Smart Motorways Programme

M4 J3 – J12

Package 2 (J3 to 8/9) Designer's Response to Road Safety
Audit (Stage 2)

Document Number: HA514451-CHHJ-GEN-SZ_ZZZZZZZZ_Z-RP-ZZ-0004

Extract from drawing HA514451- HGN-S2_ML000000_Z-DR-CH-1062 Rev C02

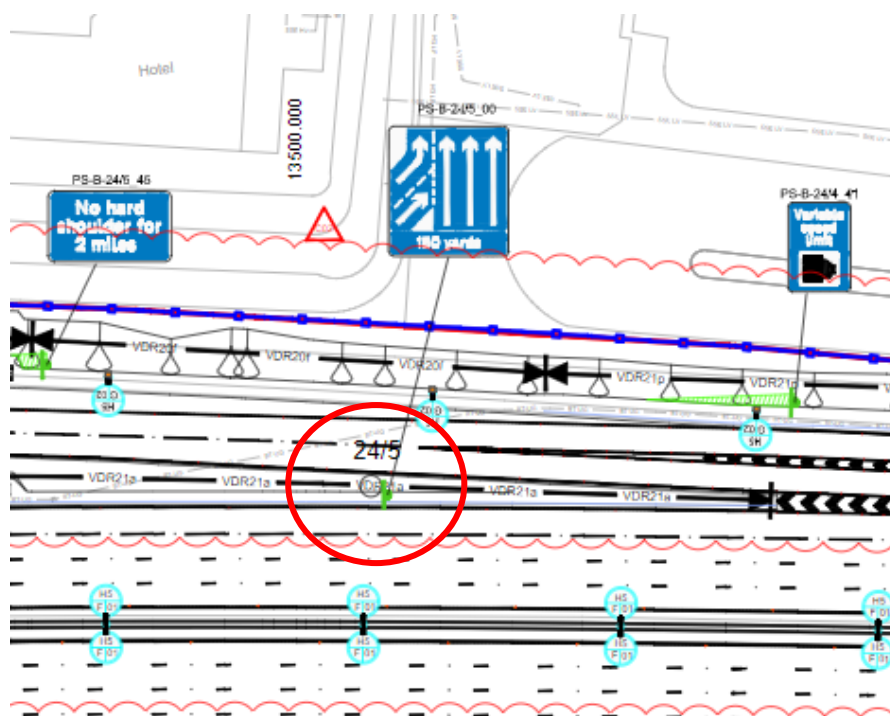
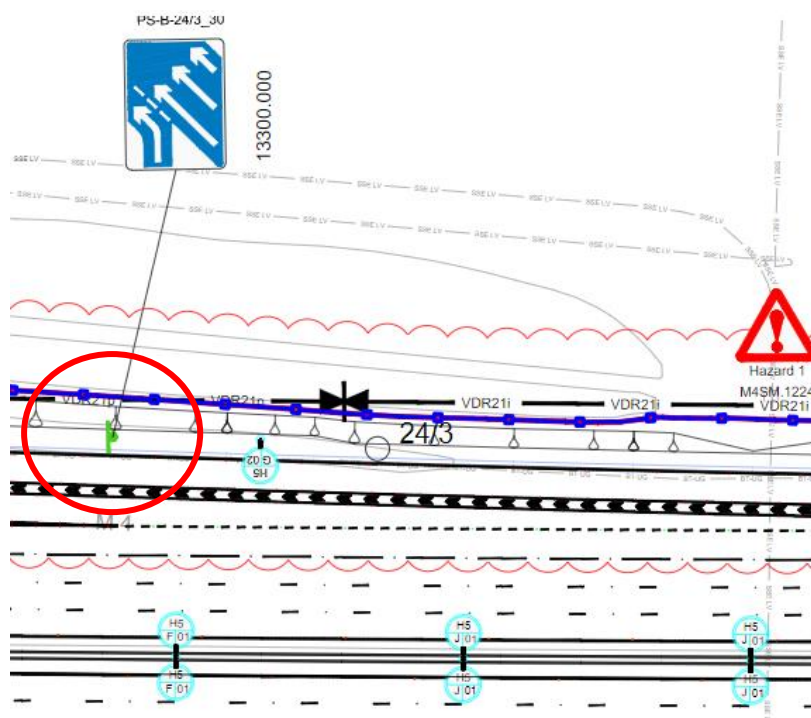
Summary: Insufficient room to accommodate sign

The 150 yard side indicating the merge layout from the slip road is located within the nosing between the merge and mainline carriageways. At this location it is unlikely that the sign can be accommodated without impacting on the working width of the RRS or potentially overhanging the carriageway. This increases the risk of the sign being struck by vehicles or the RRS not performing effectively in the event of an errant vehicle striking it.

Designer accepts the RSA problem and recommendation made by the RSA team.

150 yard slip road merging with mainline sign is outside working width of mainline and slip road RRS. The indicative position shown on the drawing is in the incorrect position, whereas the sign is located further west at ch.13529 and designed as such in the 3D traffic signs model. Drawing HA514451-CHHJ-HSN-S2_ZZZZZZZZ_Z-DR-CH12063 will be updated to reflect correct chainage

Extract from drawing HA514451- HGN-S2_ML000000_Z-DR-CH-1063 Rev C02

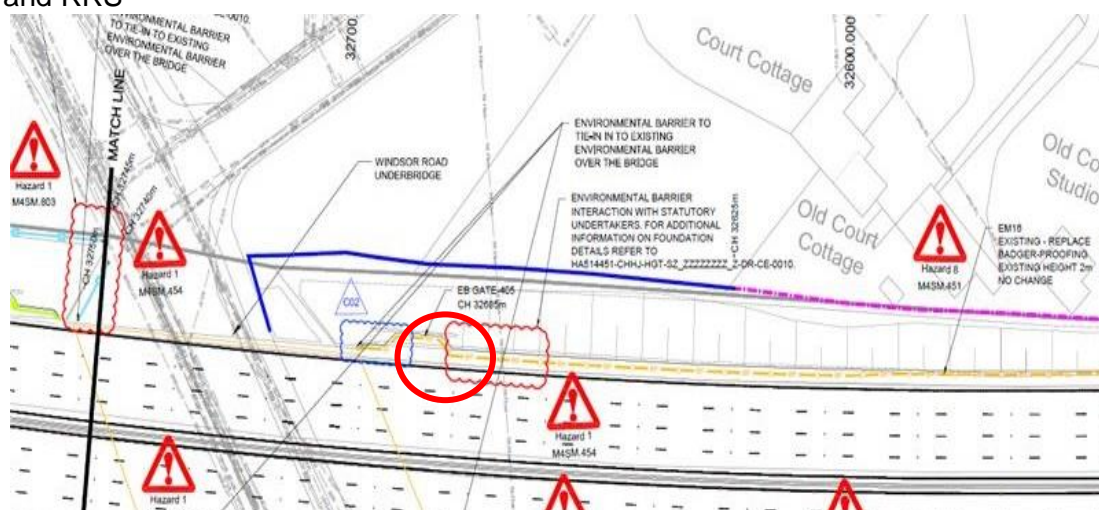
It is recommended that the correct sign face is provided to reflect the merge layout.

The following signs will be updated to show the correct merge layout:

- PS-B-24/7_80
- PS-B-24/6_40A
- PS-B-24/6-40B
- PS-B-24/5_00
- PS-B-24/3_30
